CONTRACT ADDENDUM NO. 3

April 6, 2026

NOTICE TO ALL BIDDERS FOR THE: **Topeka & Shawnee County Public Library** Staff Spaces Renovations HTK Project No.: 2001.01-021

3 LOWER LEVEL FLOOR PLAN - AREA A
1/8" = 1'-0" NORTH

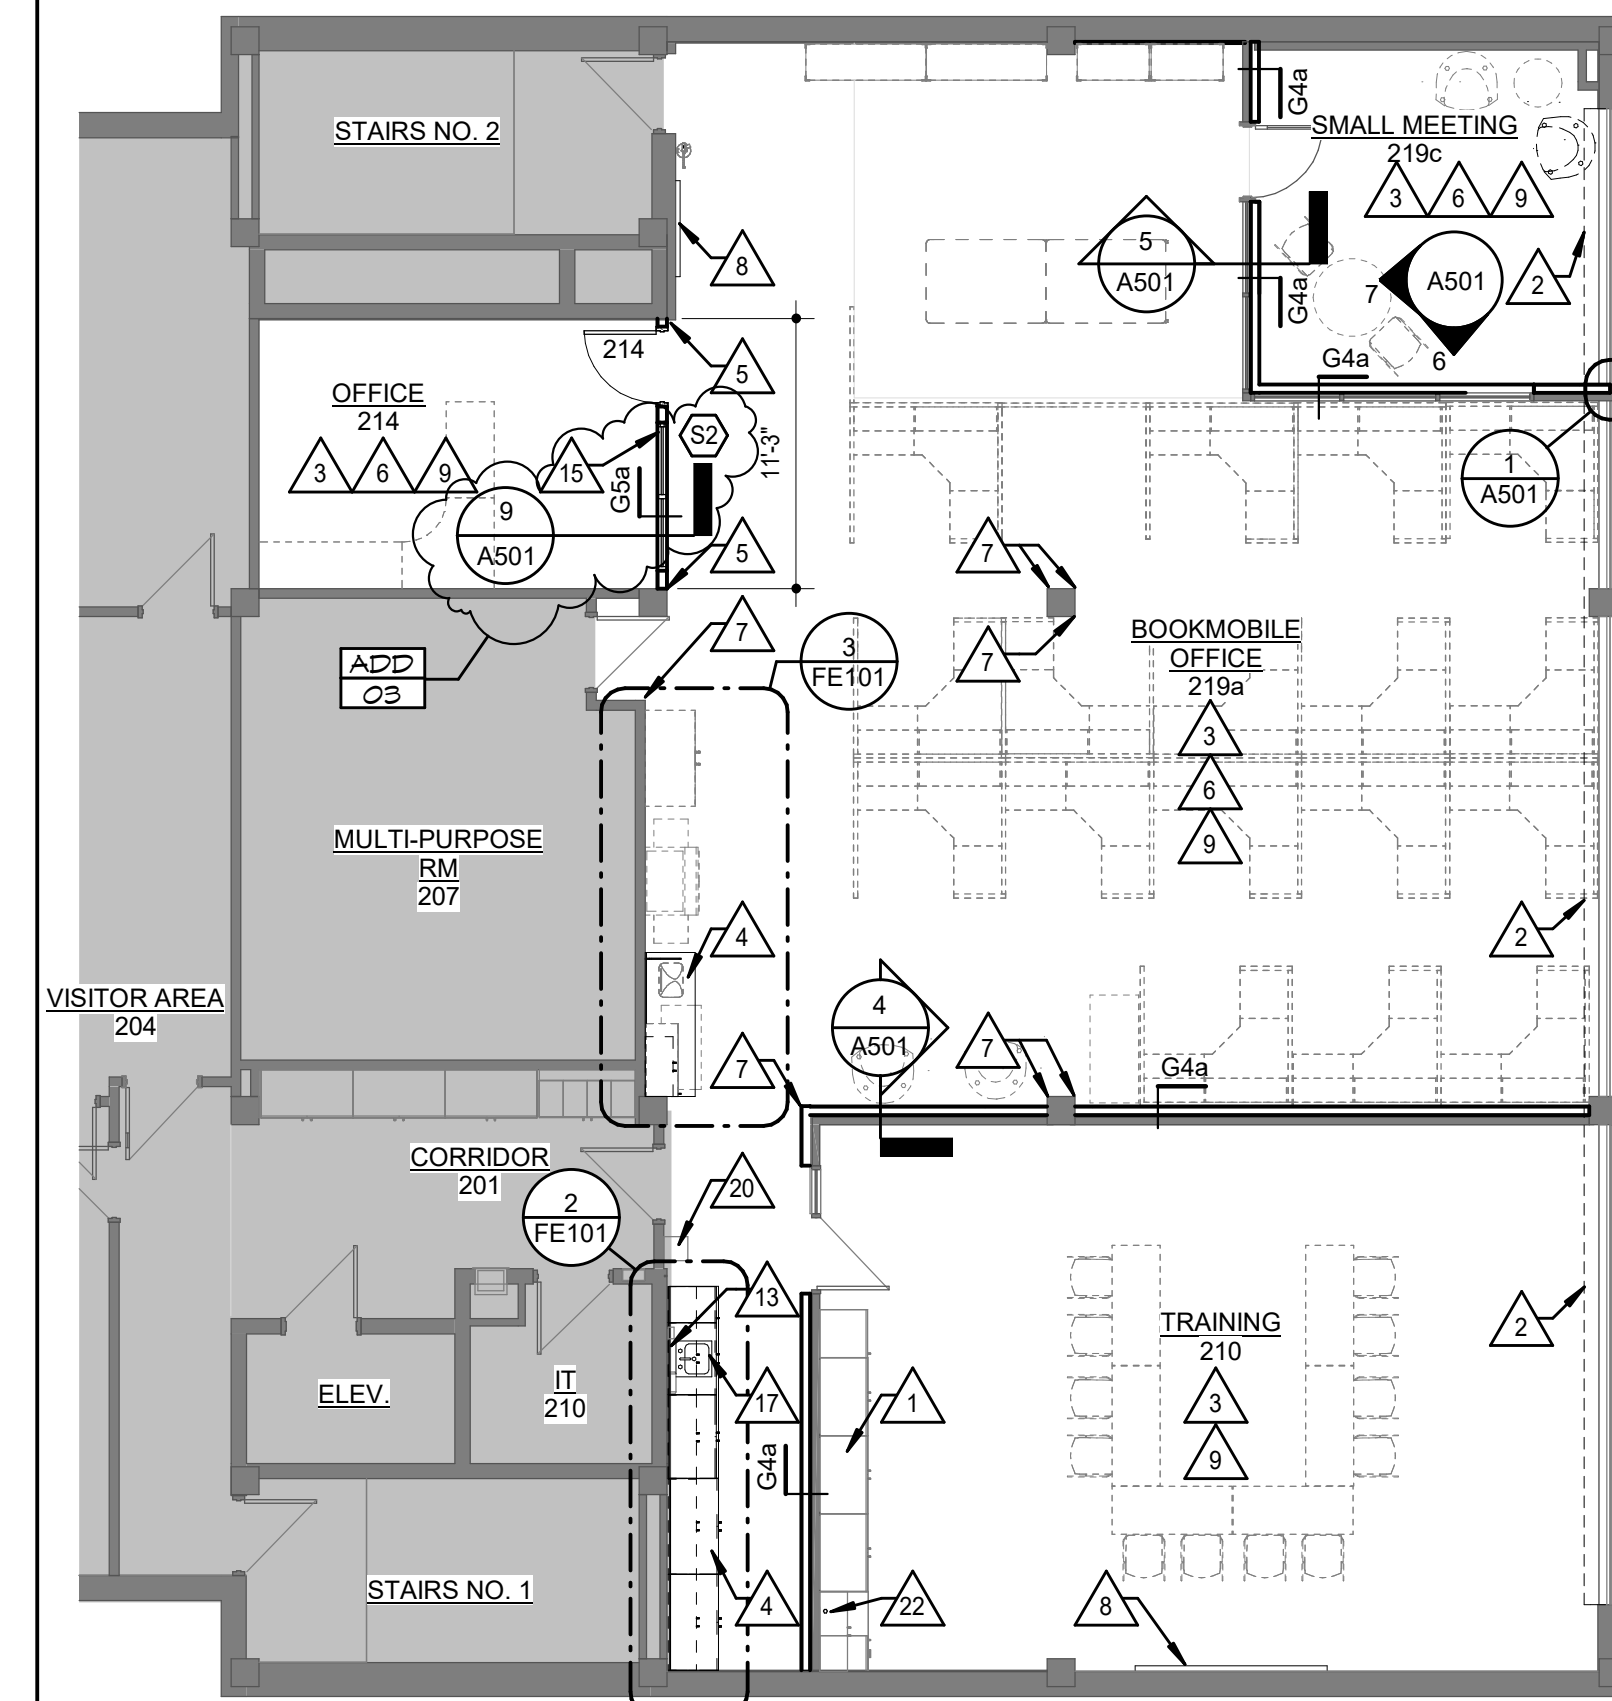
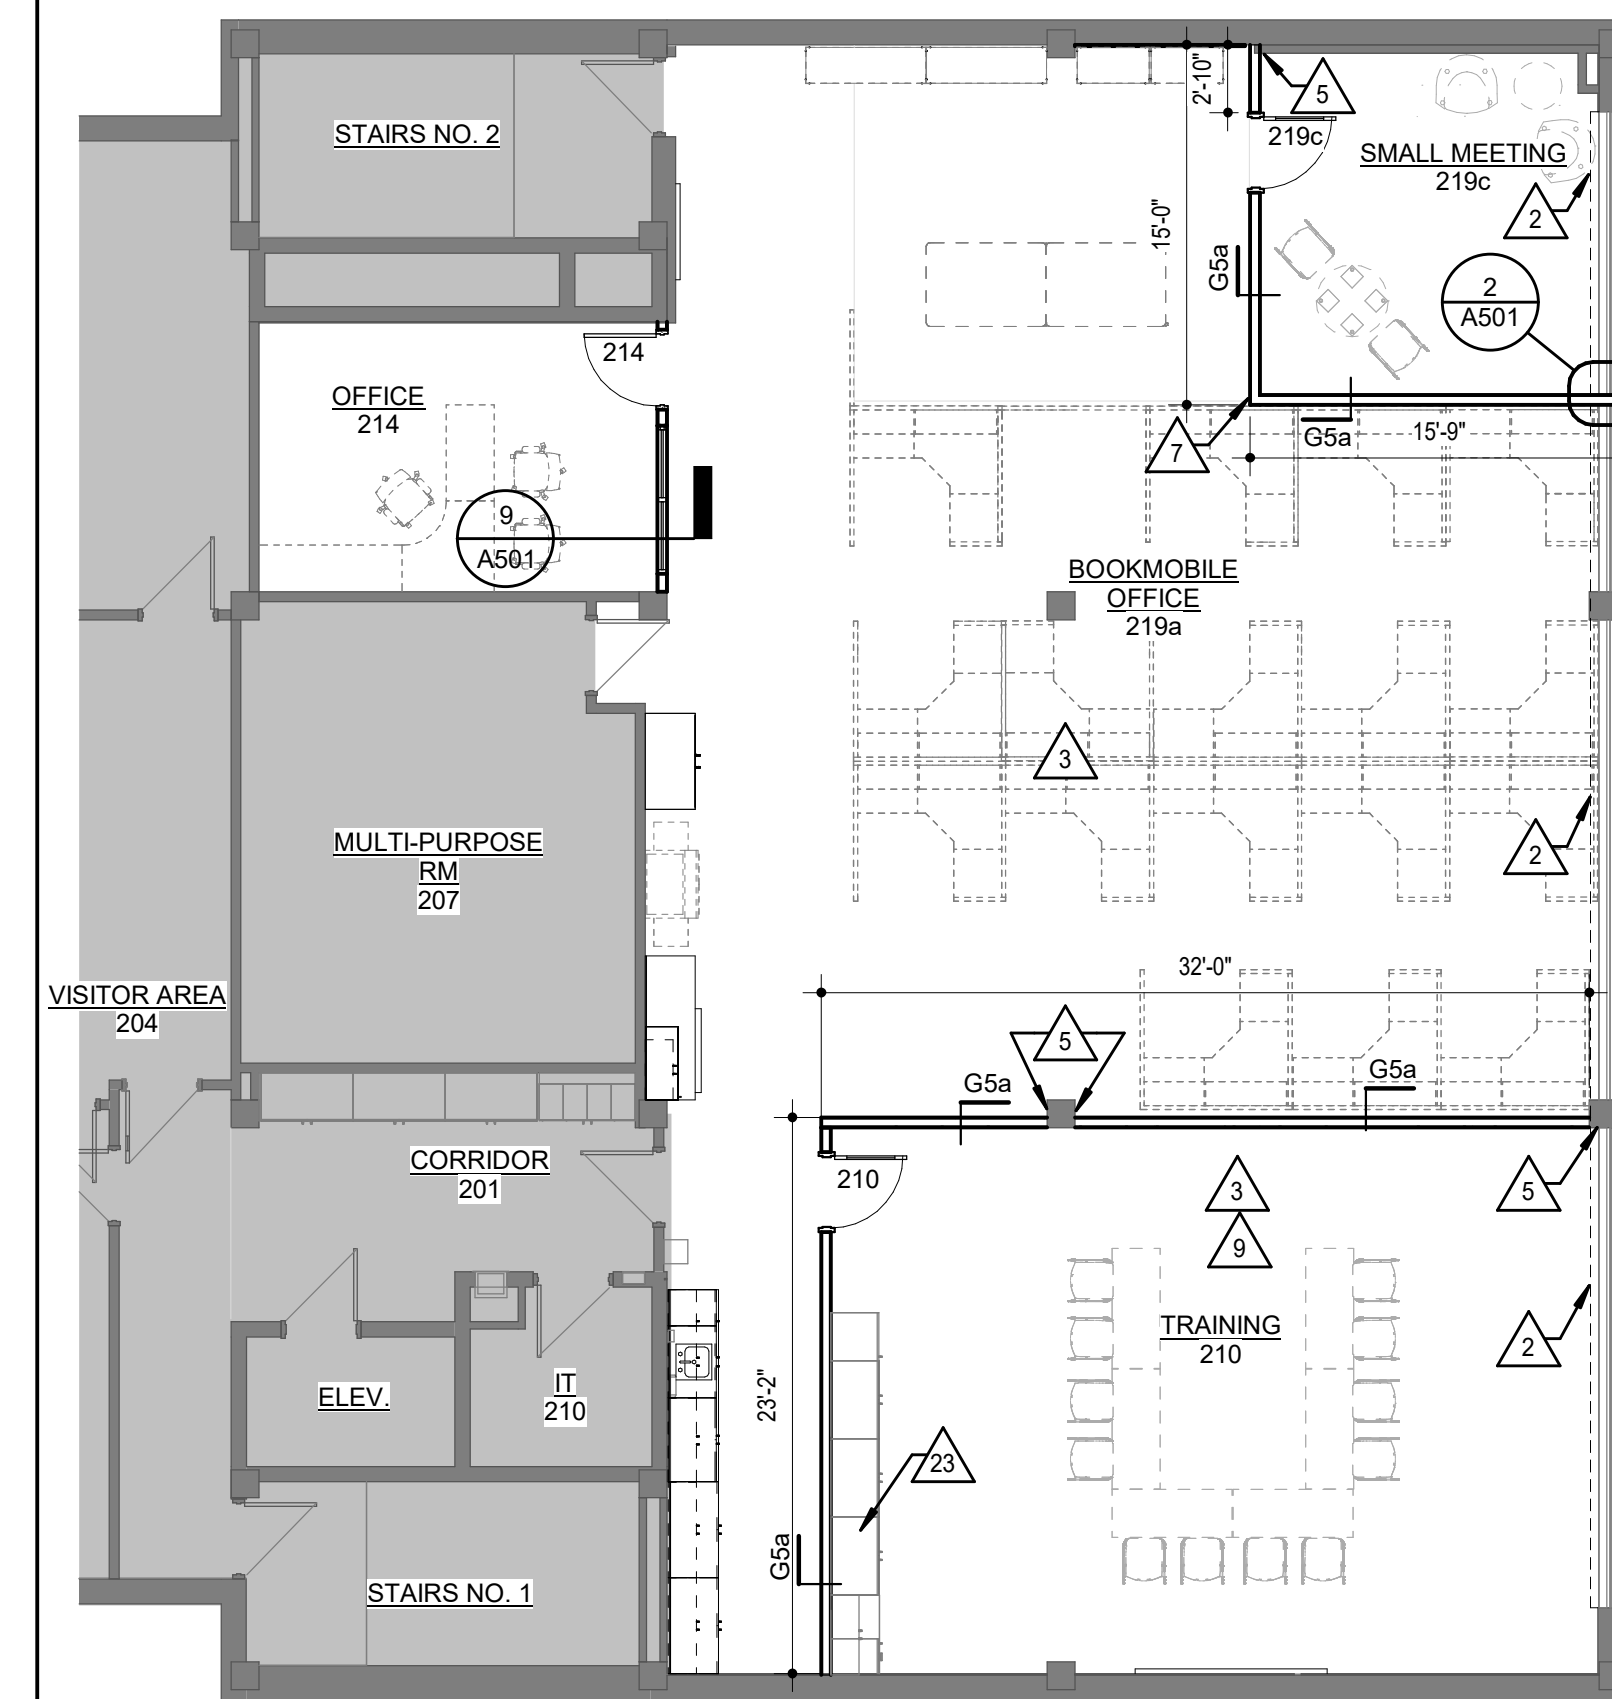
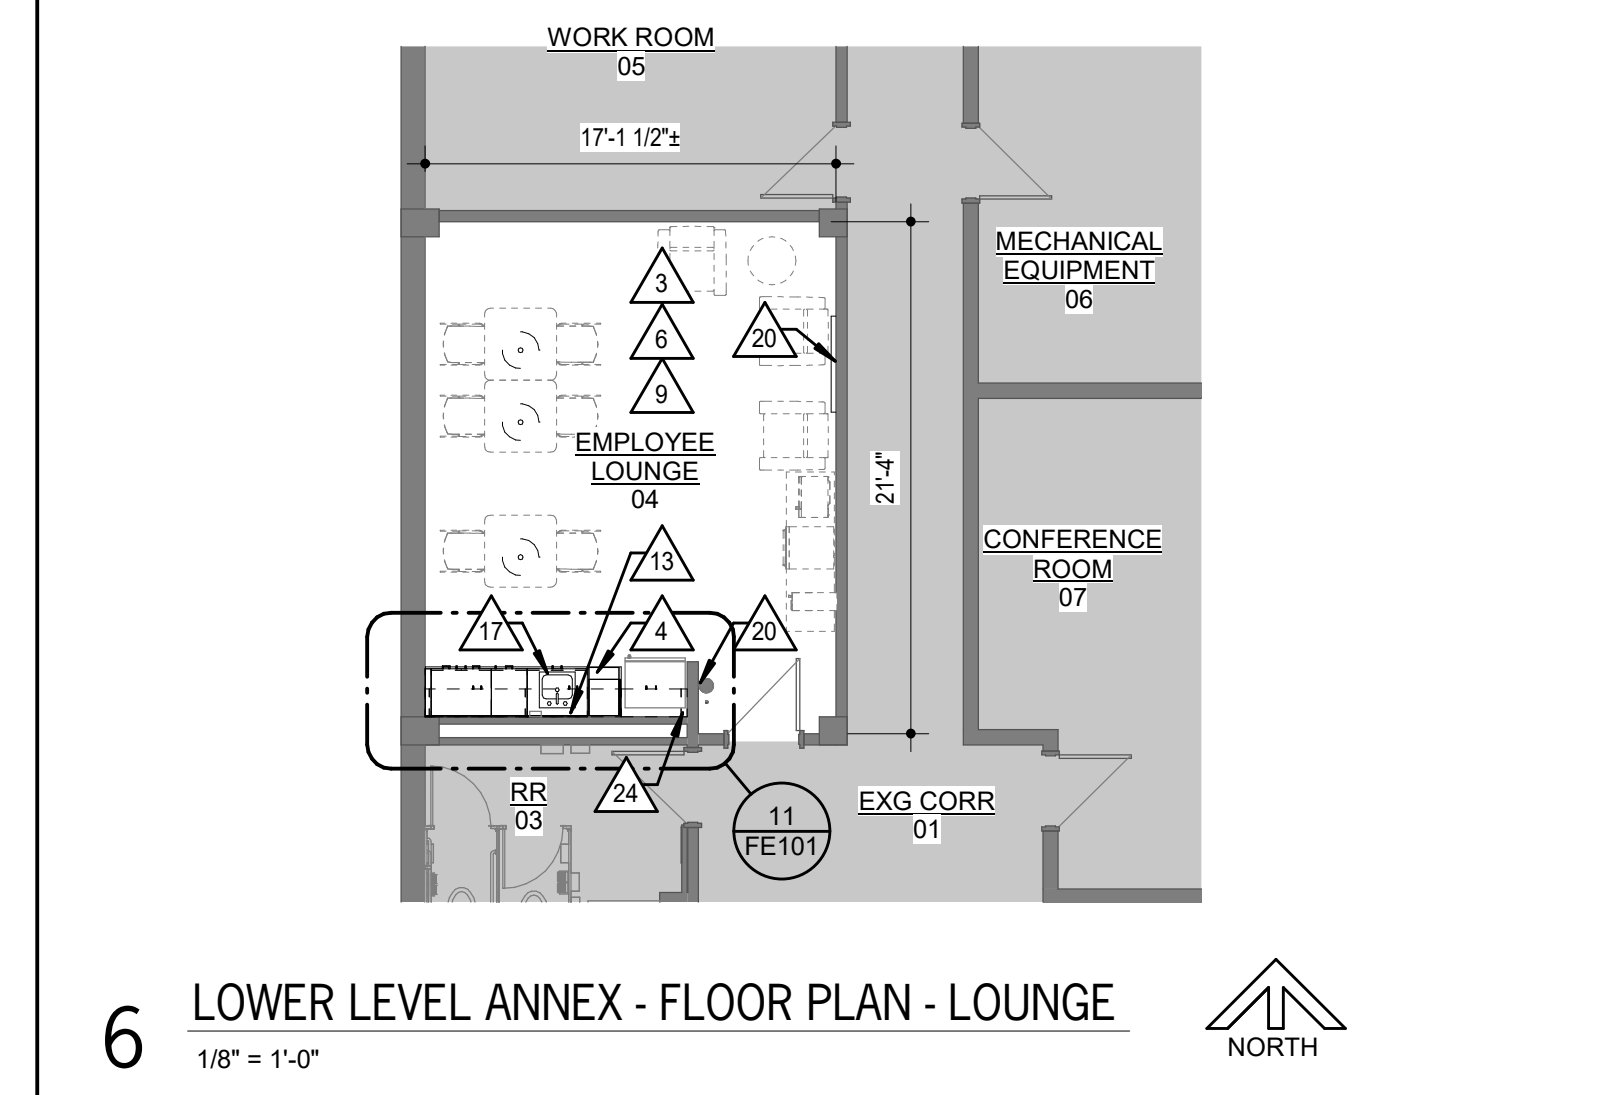
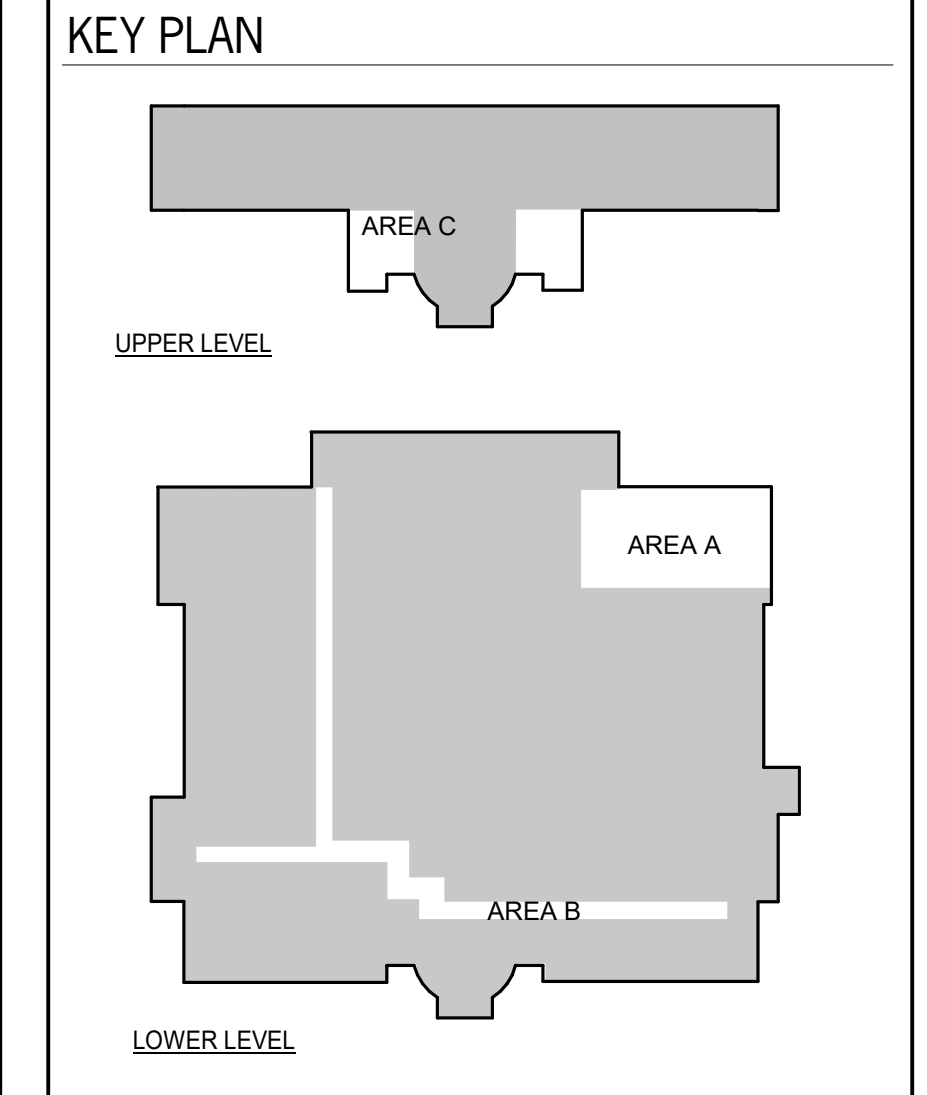
1. Revise Plan Note 15 to include Basis of Design roller shade information. Reference attached revised A101 Drawing Sheet.

- △ RELOCATE EXISTING FIRE EXTINGUISHER HERE
 - △ PROVIDE NEW ROLLER SHADE. BASIS OF DESIGN TO BE SWF CONTRACT - R-16 MANUAL ROLLER SHADE W/OUT FASCIA. BASIS OF DESIGN SHADE CLOTH TO BE SWF CONTRACT - CROSSHATCH R SERIES, R300

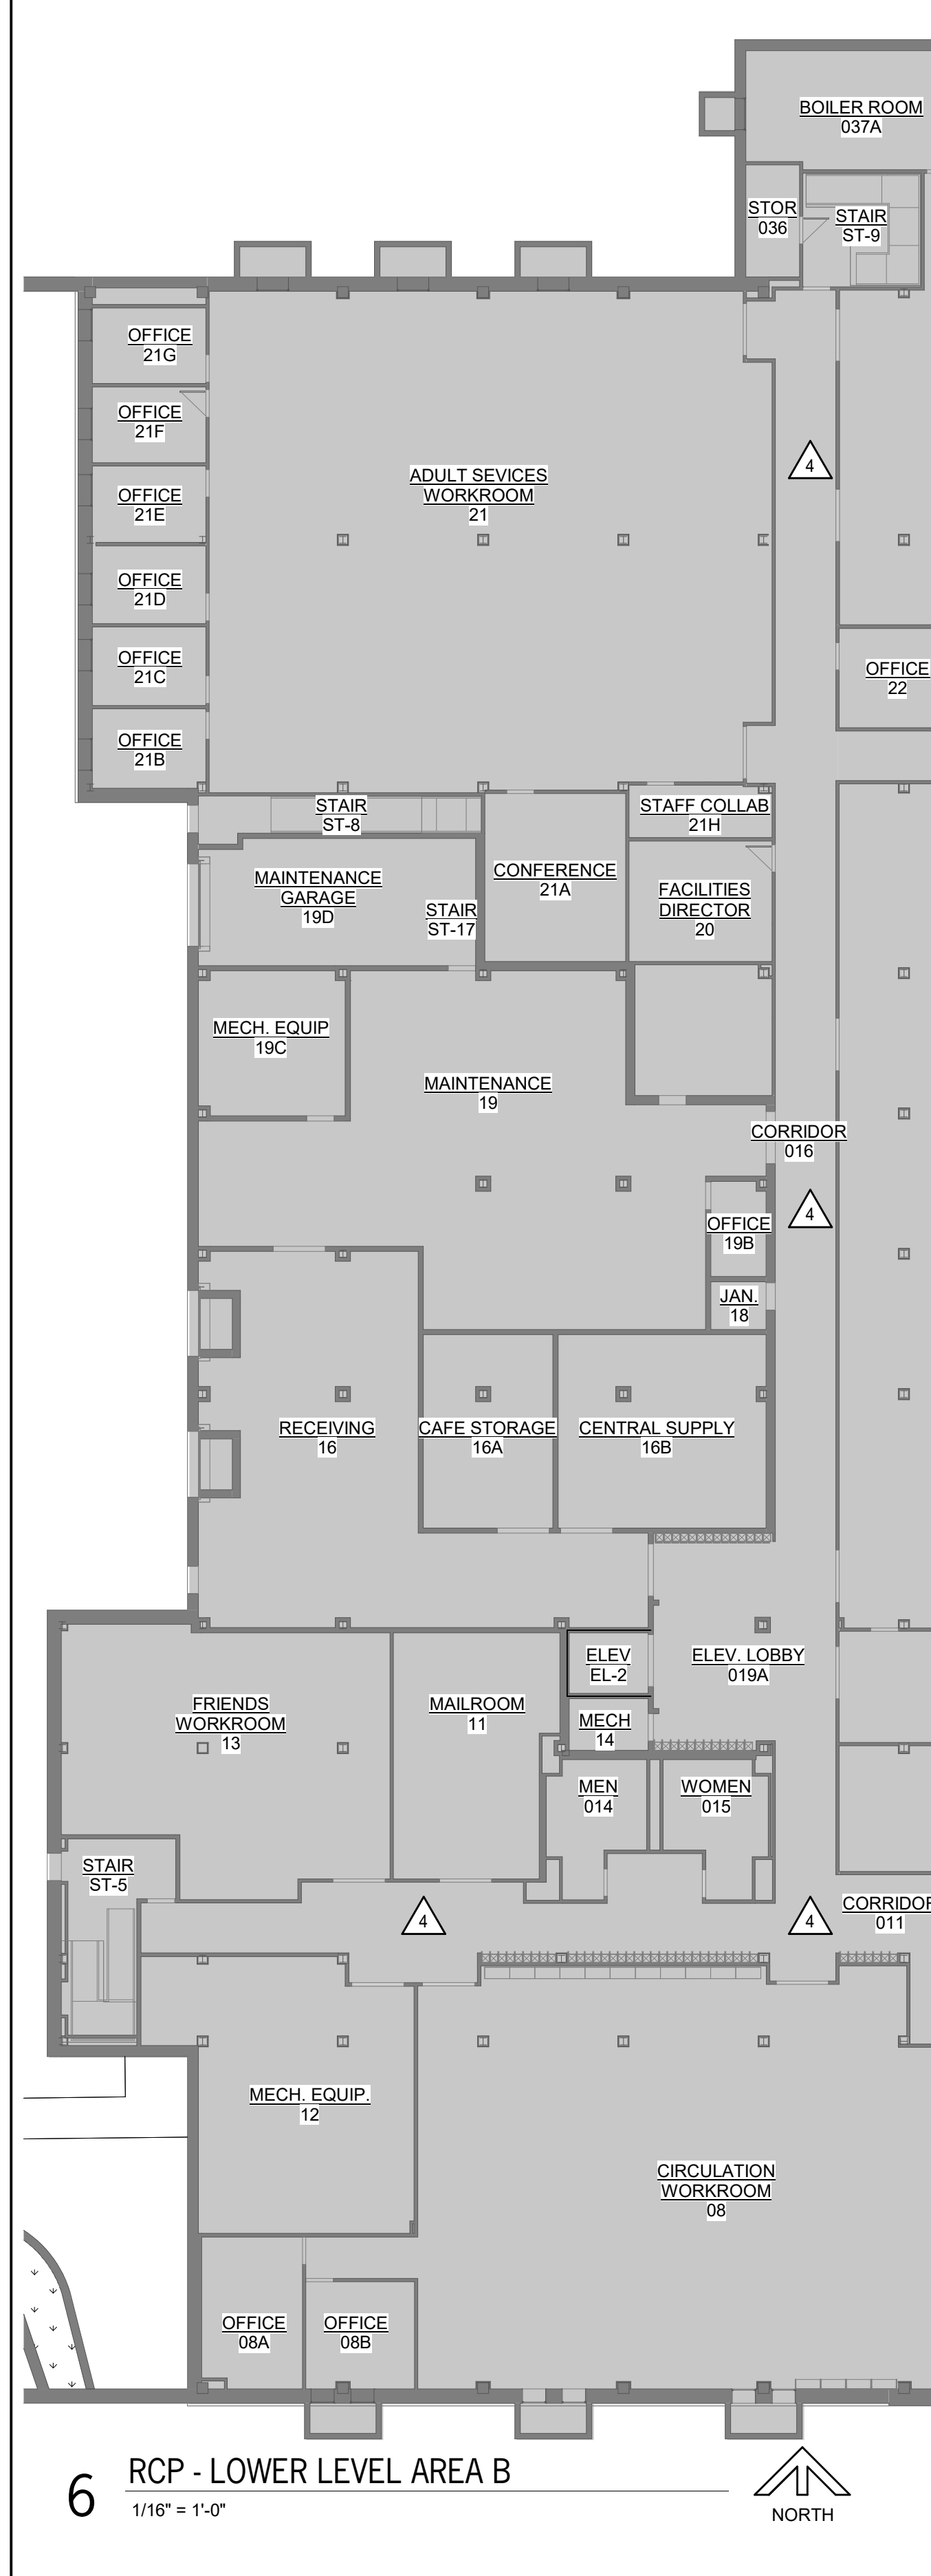
1. Add Detail View 9/A501 for mounting location of Roller Shade.
2. Add Keynotes 092900-5 & -6 as indicated on A501 Drawing Sheet.
